UNITED STATES PATENT AND TRADEMARK OFFICE

APPLICATION NO.	FILING DATE	FIRST NAMED INVENTOR	ATTORNEY DOCKET NO.	CONFIRMATION NO.
09/739,975	12/20/2000	Rieko Fukushima	02887.0199	3736

**Office Action Summary**

**FIG. 1**

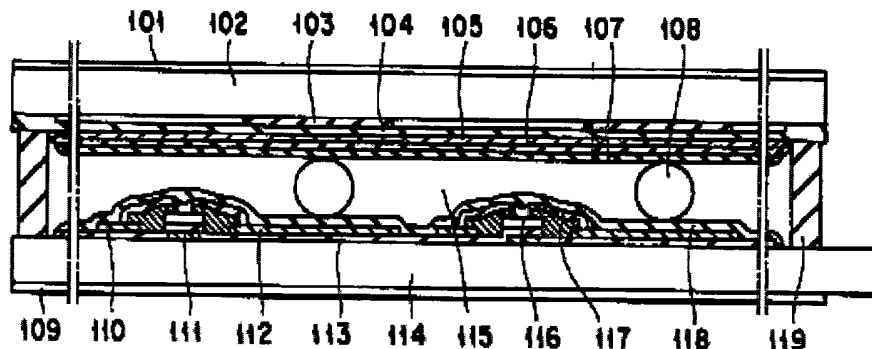
As to claim 8, Saishu discloses in Figure 1 (col. 6, line 60 through col. 8, line 45), a liquid crystal display element comprising: a first substrate, 114; a switching element disposed on said first substrate; a second substrate, 102, counter to said first substrate; a first alignment layer formed over said switching element, 118; a second alignment layer, 107, formed over said second substrate, wherein said first and second alignment layers are rubbed in rubbing directions (col. 7, lines 35-40); a light modulating layer, 115, disposed between said first and second substrates wherein the light modulating

layer comprises an anti-ferroelectric liquid crystal material having a thresholdless voltage-transmittance characteristic (col. 7, lines 43-45); and a filter, 104, formed on said second substrate, wherein said filter allows specific wavelengths of light to pass.

As to claim 9, Saishu discloses the liquid crystal display element of claim 8 wherein the anti-ferroelectric liquid crystal material (col. 7, lines 43-56) is subject to an alignment process (Applicant's phase comprising Iso, SA and SC).
